General Advisory

PowerG Wireless Vanishing Door/Window Contact with Firmware Version 1.07

Product: PowerG Wireless Vanishing Door/Window Contact (PG9303)

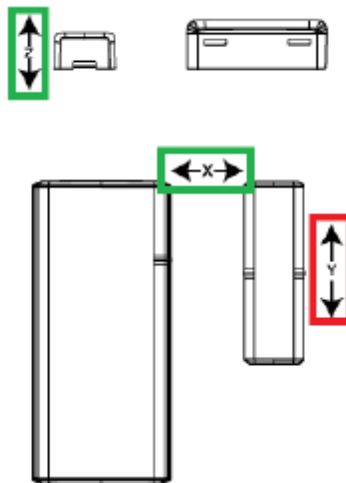
A. To resolve the reed switch issue, an updated version of PG9303 firmware was developed, and has begun shipping. This new version can be identified by (1) a Date-of-Manufacture of 4/1/2019 or later printed on the packaging and device; (2) F/W V1.07 printed on the packaging; 3) Serial Number on device or packaging with first four digits in the format XX19, where XX is 19 or higher. An image comparison of V1.03 and V1.07 packaging and detectors is included below to assist with this identification.
